**Duquesne Light**

Reference: Beaver Valley Power Station  
Docket No. 50-334, License No. DPR-66  
Appendix R to 10 CFR 50 - Exemptions

By letter dated June 30, 1982, the Duquesne Light Company requested exemptions from Section III.G. of Appendix R to 10 CFR 50 for five fire areas. By letter dated October 22, 1982, we provided additional information with regards to the subject exemptions. The NRC's draft Safety Evaluation Report of these requests was received by Duquesne Light Company on November 30, 1982.

VENTILATION - FIRE AREAS CR-1,2,3, & 4  
PHYSICAL LAYOUT-SERVICE BLDG

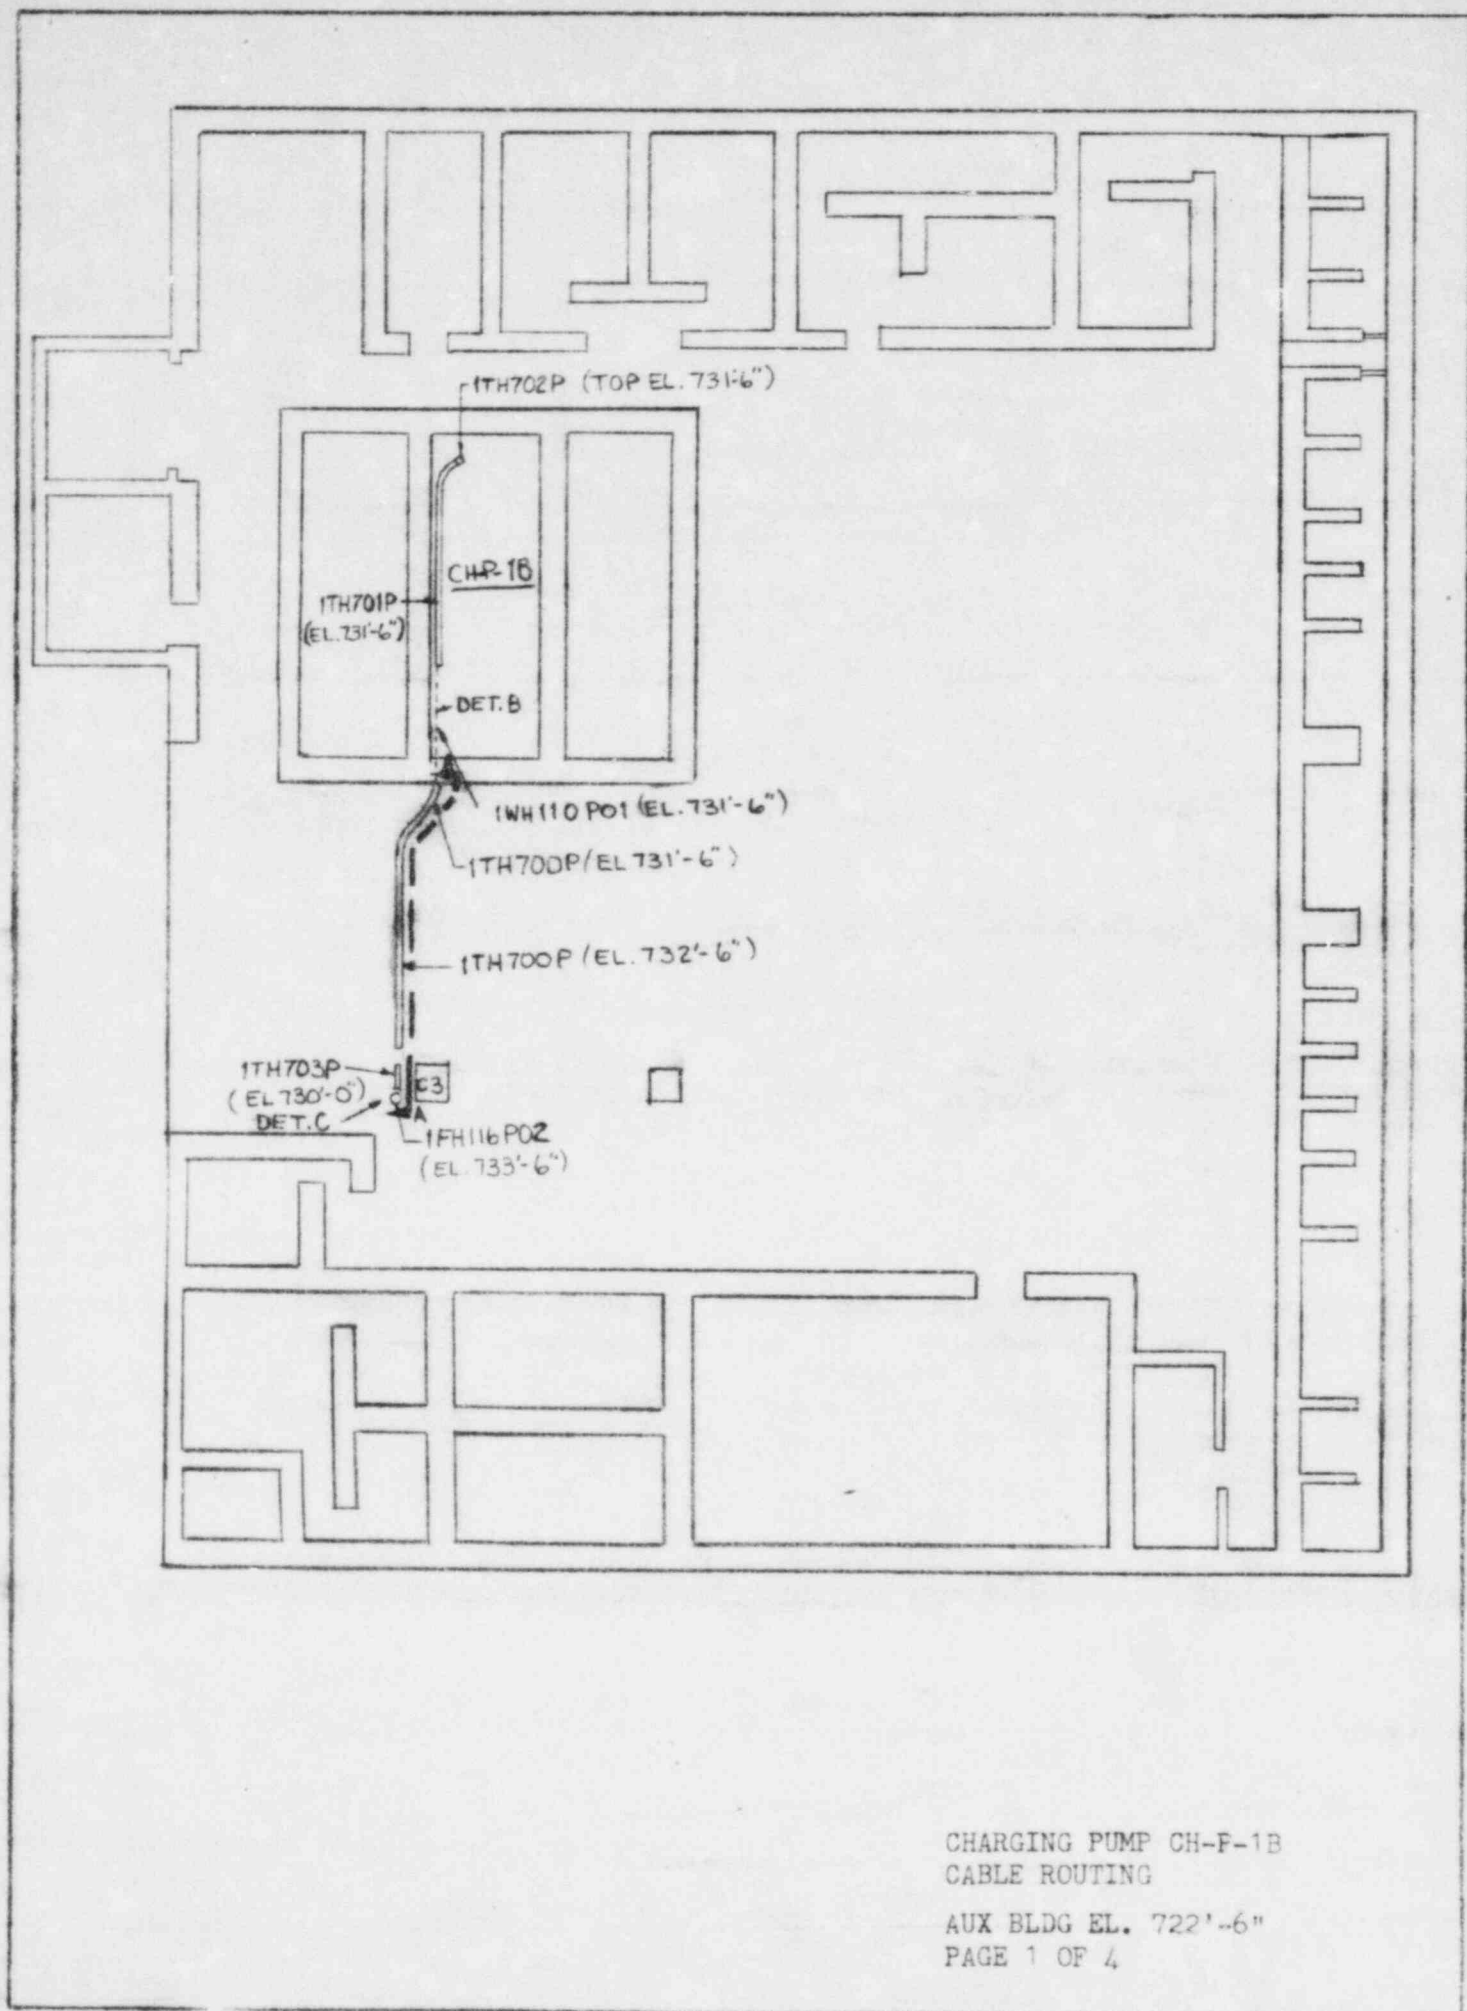
The draft SER stated that physical isolation does not exist between the common ventilation duct work between the control room (CR-1) and area CR-4 (Process Instrument Room). A sketch of the ventilation duct work denoting fire-rated dampers is attached to show the automatic physical isolation capability between the control room and the surrounding perimeter areas.

CHARGING PUMP CH-F-1B  
CABLE ROUTING

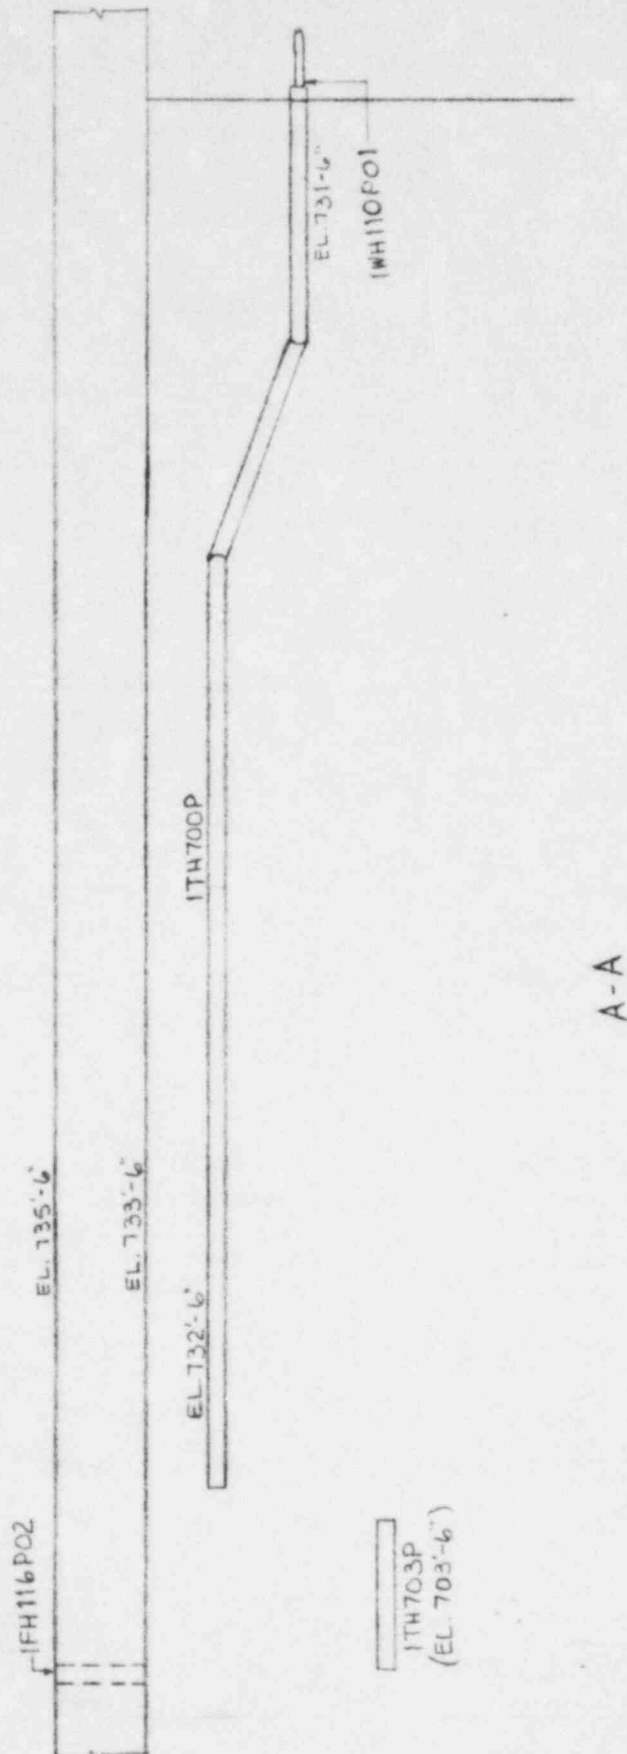
1. Charging capability (CH-P-1A, 1B, 1C)  
The raceways associated with CH-P-1B as shown on the attached sketches will be separated from the general fire area PA-1G by a one-hour fire barrier to protect it from "an exposure fire of moderate duration (5-10 minutes)" as noted in your draft SER. See attached sketches (pages 1 through 4) for description of cable routing and details.

1. THE POWER CABLE 1CHSBPH300 FOR CHARGING PUMP CH-P-1B IS ROUTED OUTSIDE THE CHARGING PUMP CUBICLE TO THE 735'-6" ELEVATION OF THE AUXILIARY BUILDING VIA RACEWAYS 1WH110P01, 1TH700, 1TH703 AND 1FH116P02.
2. NO OTHER CABLES ARE ROUTED IN THE RACEWAYS LISTED IN NOTE 1.
3. DATA ON RACEWAYS OF NOTE 1.

ALTERNATE FLOW PATH TO THE CHARGING PUMP SUCTION

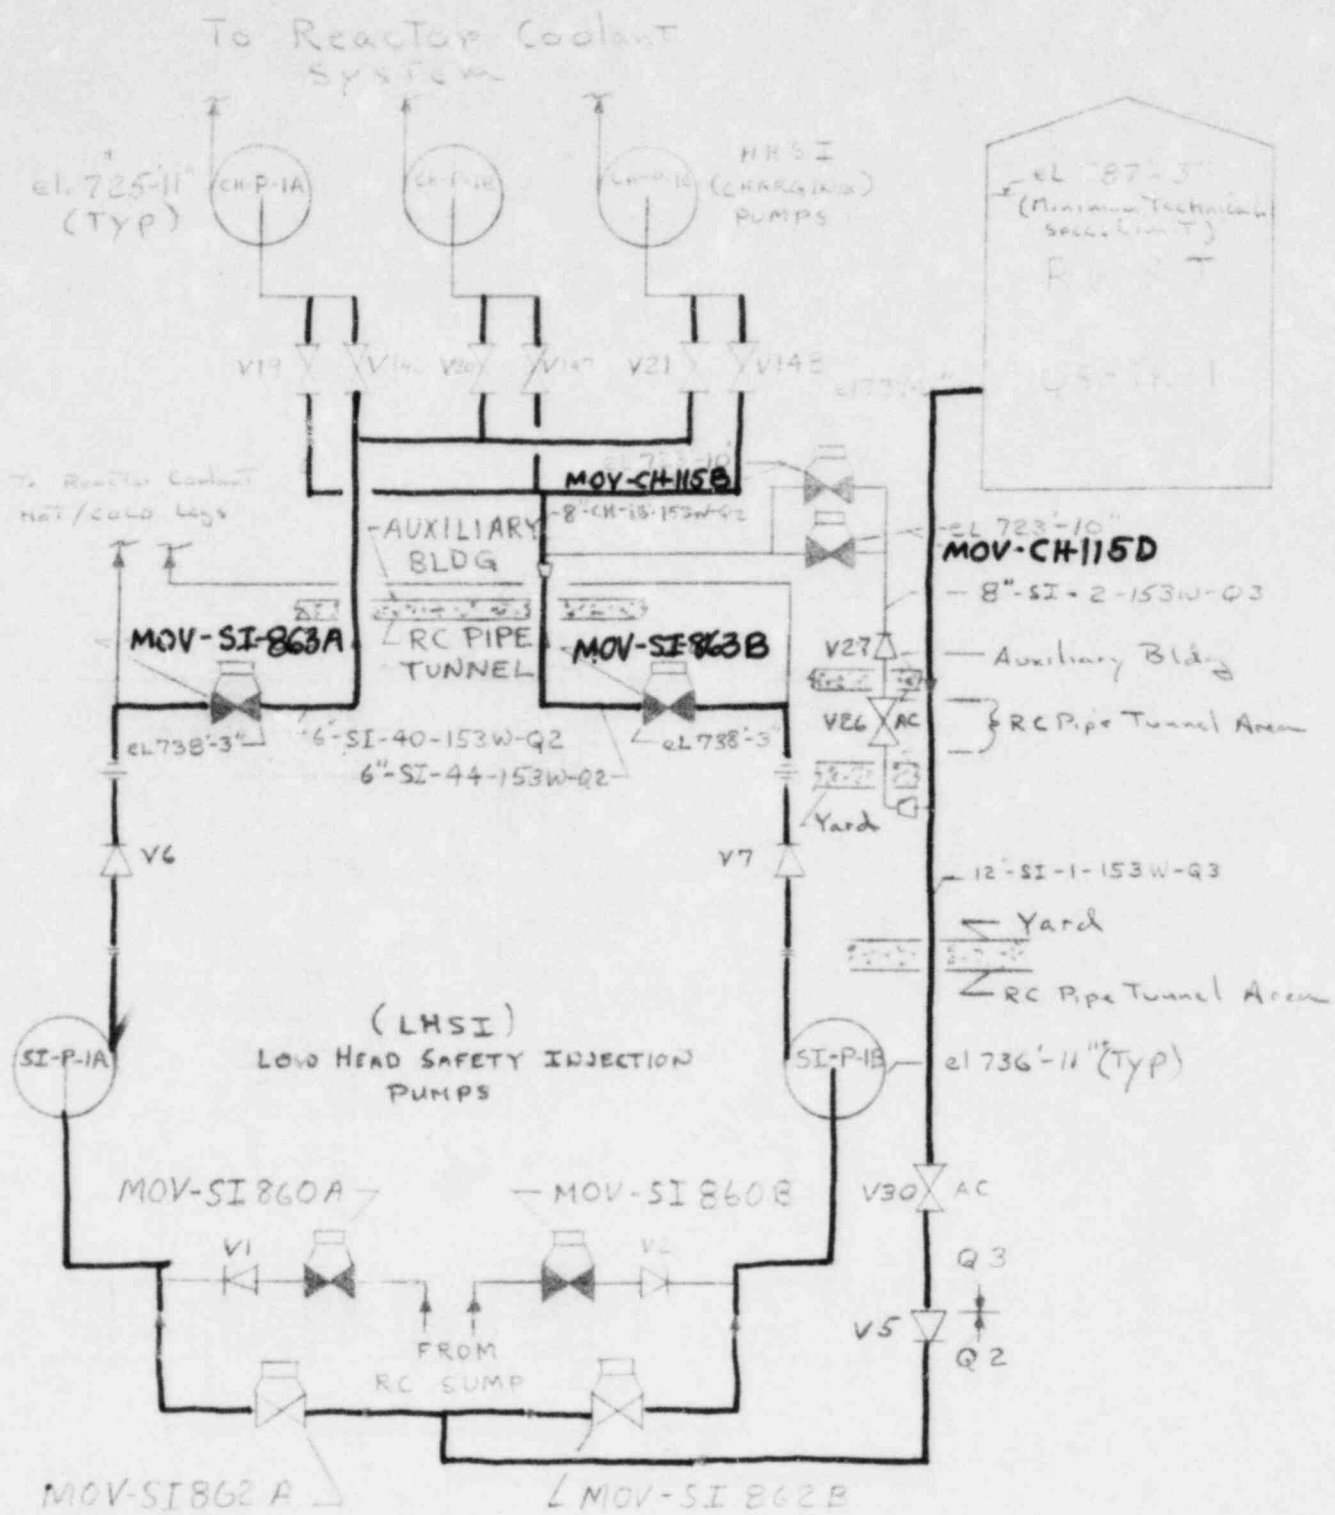
4. Charging Pump Suction Valving MOV-CH 115 B & D. These normally shut parallel valves are interposed between the charging pumps and the RWST. If these valves are rendered inoperable by virtue of a fire in PA-1G, an alternate flow path as detailed on the attached sketch will be available. The charging pump would draw suction from the RWST through the idle low head safety injection pumps SI-P-1A, 1B. The only action required of the control room operator to make thus flow path available would be to open MOV-SI 863A or B located on Benchboard A, or, locally if necessary.
